**2018 GROUP A PROPOSED
CHANGES TO THE I-CODES
COLUMBUS COMMITTEE ACTION
HEARINGS**

2018 GROUP A – PROPOSED CHANGES TO THE INTERNATIONAL PLUMBING CODE

PLUMBING CODE COMMITTEE

Figure 4 - Illustration Showing Drainline Transport Distance at various flow rates

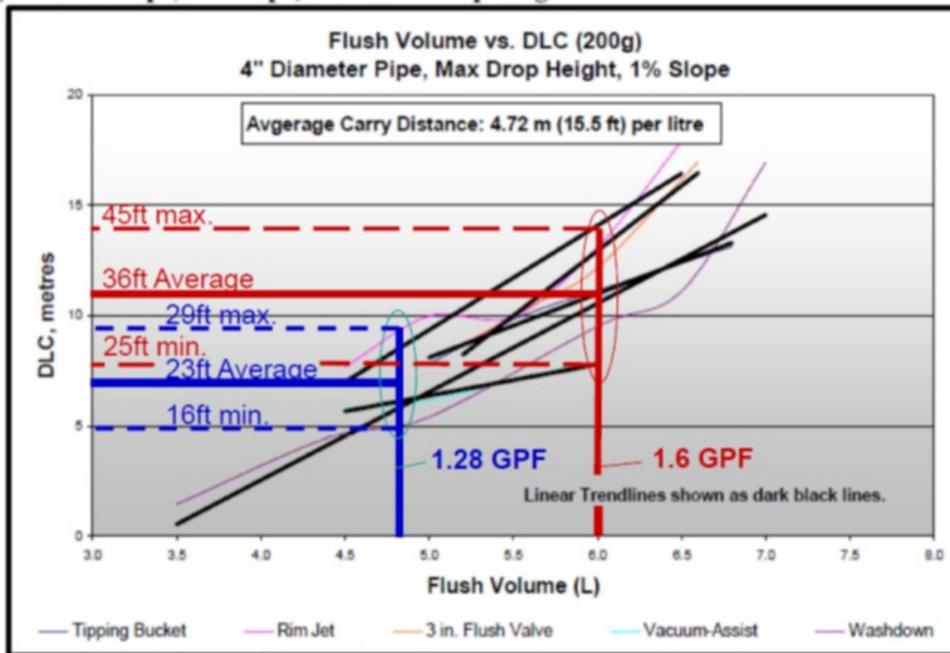
Studies by two engineers, Bill Gauley and John Koeller, show when various models of 1.6 and 1.28 Gallon per flush GPF water closet's were tested, tests showed drainline transport of solids is generally less in 1.28 GPF water closets when compared to 1.6 GPF water closets. There was a reduction in the drainline transport of about at 37 percent when reducing flows from 1.6 to 1.28 GPF. The transport distance was reduced from 36 feet on average to about 23 feet on average. (See Figure 4). With even lower flows being proposed, it will be difficult if not impossible for larger horizontal drainage systems to transport solids. Drain blockages will become more common at lower flow rates. In high-rise vertical buildings, it should be relatively easy to transport the waste a short distance to a vertical stack if the stack is within about 15 feet of the fixtures. There should be enough additional uses of water in the stack in a high-rise building to provide sufficient drainline transport at the lowest level in the horizontal building drain.

Drain flows are getting to the point where the flows are insufficient to transport solids down the drain. If drain flows are reduced, and the drain pipes are the same size, then the hydraulic depth of flow will be less. In older buildings, there will likely be more problems than in newer buildings that can be designed with smaller drains with more slope.

Figure 5 - Illustration showing Less Water in Drains Due to Water Conservation

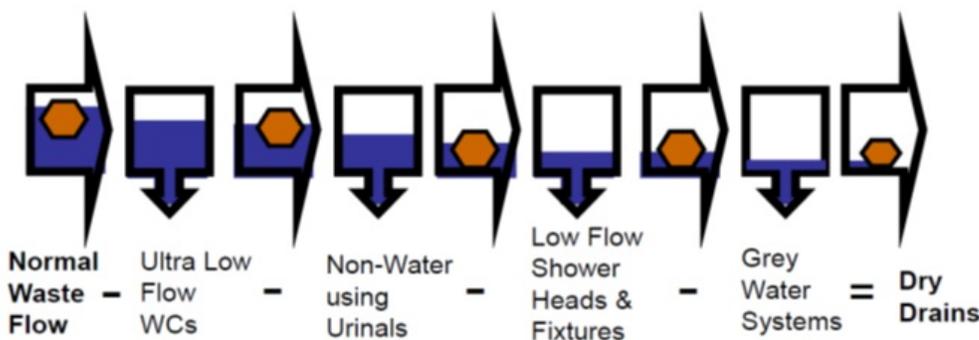
To compound the issue, when a greywater reuse system collects discharged water from fixtures for reuse to flush water closets or for sub-surface irrigation purposes, it is taking water away from the sanitary drainage system. (See Figure 4). The wastewater flow needs to be maintained at a level to keep the hydraulic depth of flow sufficient for proper water velocities and drain line transport.

Figure 6 - Less Water in Drains Due to flow into Horizontal Branch Connections

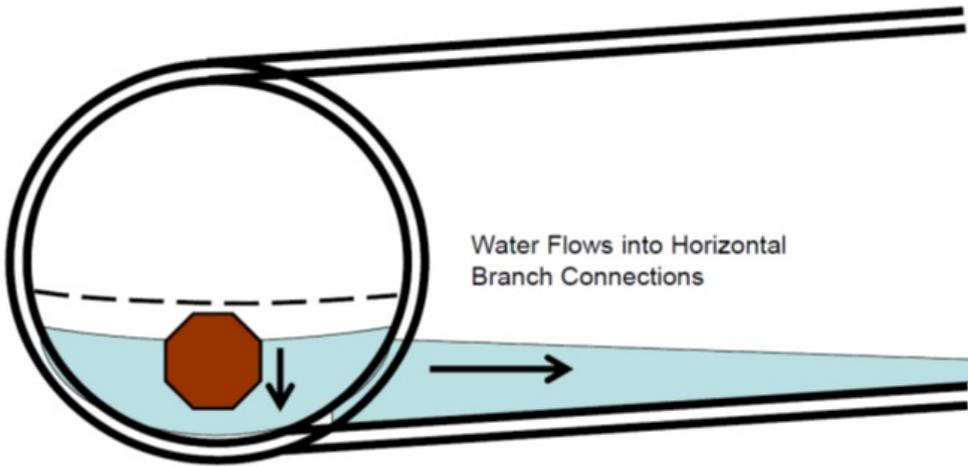
and reduced the hydraulic depth of flow because of the diversion of waste. The stack should use a 45 and a Y fitting rolled to allow a rolled up 45-degree entry into the horizontal drain.

Some of these are already required in our codes. We should also be more aware of using directional drainage pattern fittings as water closet flow rates are further reduced. An interesting thing of note is the fact that the minimum slope in Australia is 1.67 percent and in the U.S., the minimum slope is 1.0104 percent (1/8 inch per foot) because they generally use smaller drain pipes.
